Job Name
THE DUTCHESS 2ND FLOOR

21071981F2

UFP MID-ATLANTIC, LLC
A UFP INDUSTRIES COMPANY

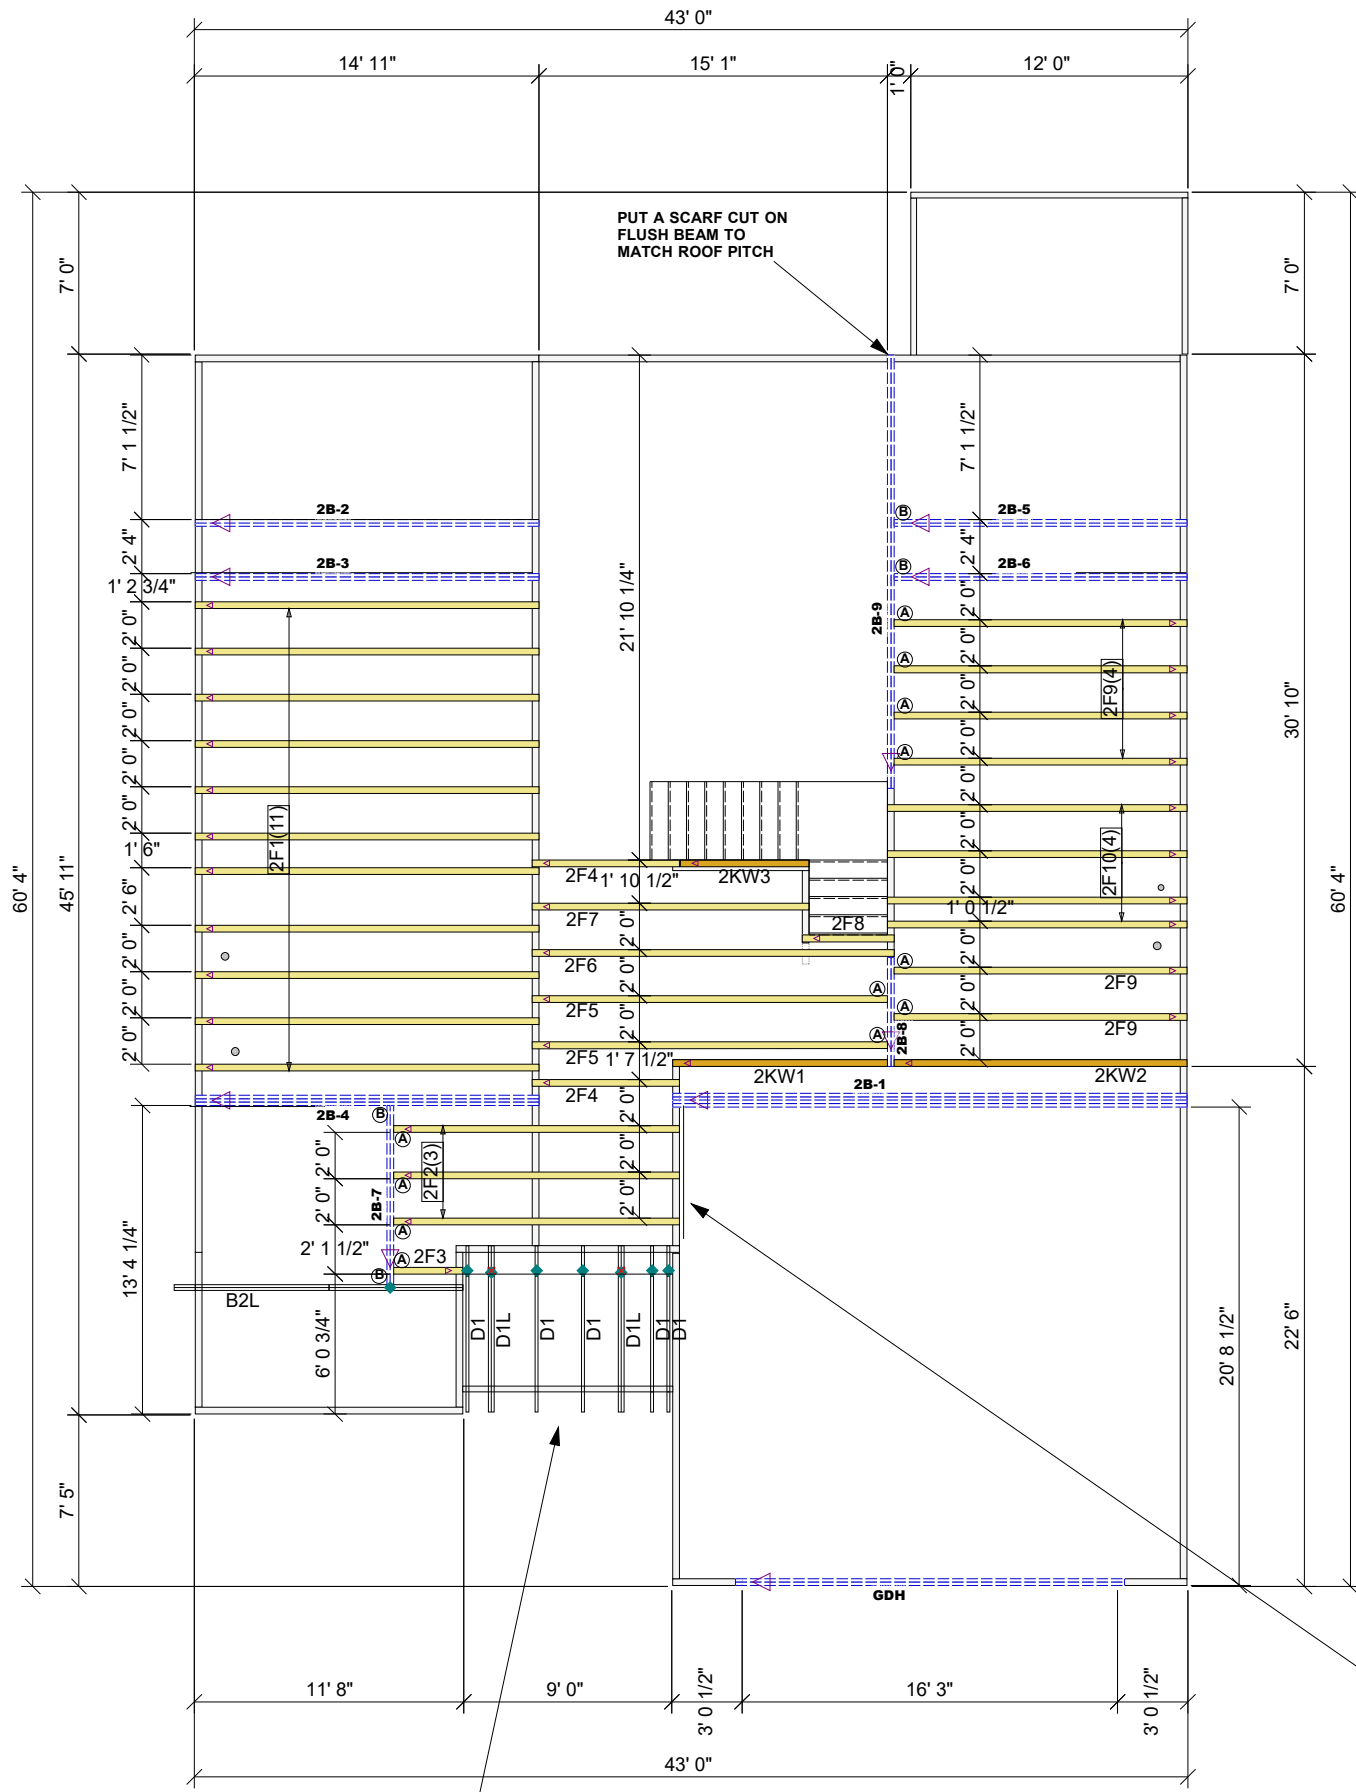
CHANGED PORCH ROOF PITCH TO A 4/12 FROM A 5/12 SHOWN ON PLAN AS TO NOT INTERFERE WITH WINDOW.

PORCH ROOF TRUSSES CARRY PART OF FLOOR ABOVE. SEE TRUSS PROFILE.

I HAD TO ADJUST THE RIGHT LOFT WALL TO THE LEFT TO STACK WITH GARAGE WALL. LOFT IS 1'-4 1/4" SMALLER DUE TO THIS CHANGE.
